Product Change Notification / ALAN-24AINW535

CCB 5336 Final Notice: Qualification of MTAI as a new assembly site for SST26VF016-80-5I-S2AE and SST26VF016-80-5I-S2AE-T catalog part numbers (CPN) available in 8L SOIJ (.208in) package.

CCB 5336
Pre and Post Change Summary
PCN# ALAN-24AINW535

Pre and Post Change Summary

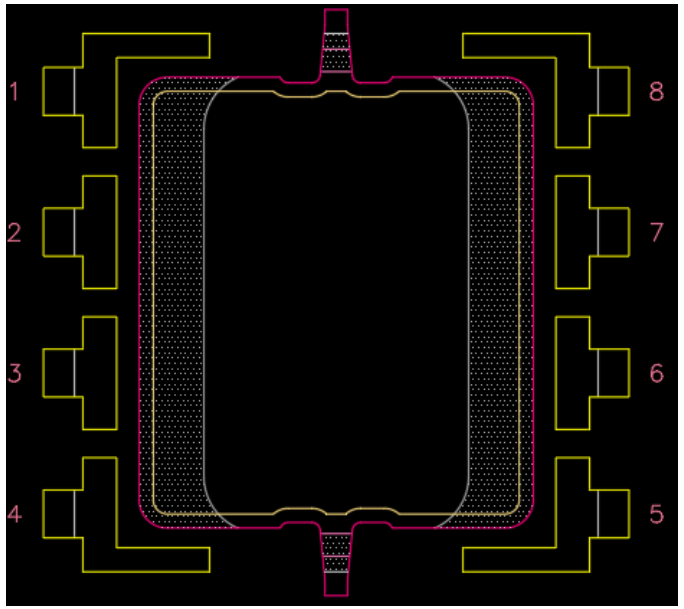
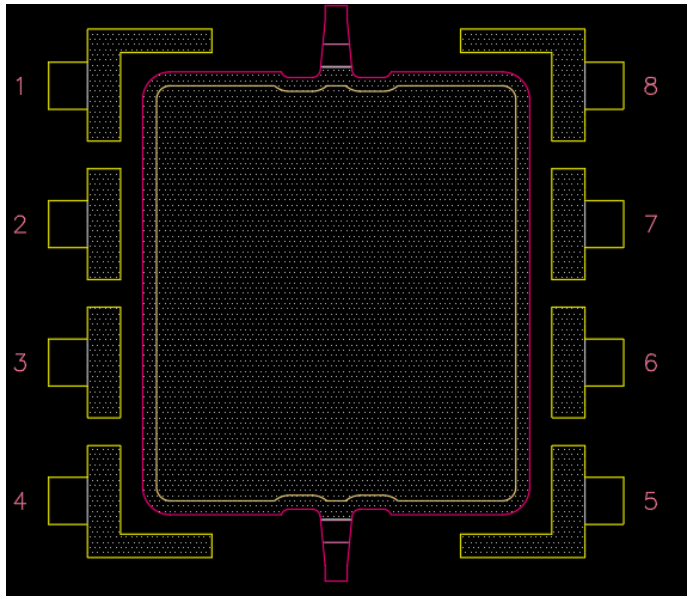
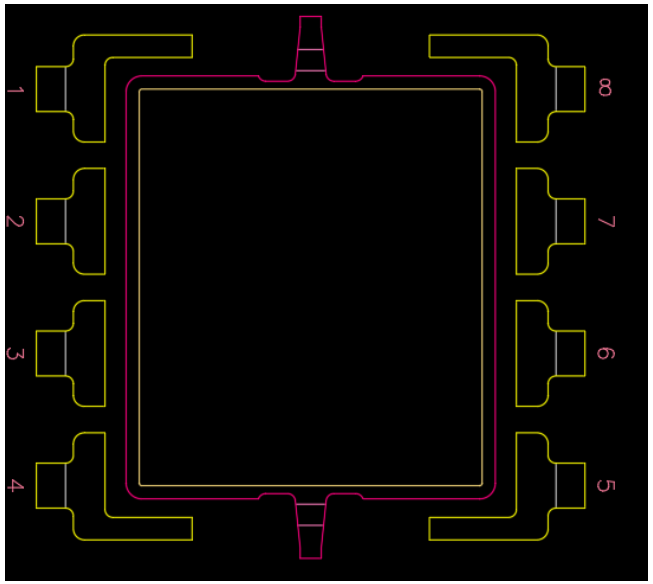
Assembly Site	Greatek Electronic Inc. (GTK)	Lingsen Precision Industries, LTD. (LPI)	Microchip Technology Thailand (MTAI)
Wire Material	Au	Au	Au
Die Attach Material	8340	8340	8390A
Molding Compound Material	G600	G600	G600V
Lead-Frame Material	C194	C194	CDA194
Lead-Frame Paddle Size	140 x 160 mils	142 x 168 mils	140 x 160 mils
DAP Surface Prep	Ag spot	None	Bare Cu
MSL	3	3	1
See Pre and Post Change Summary attachment for comparison

GTK	LPI	MTAI
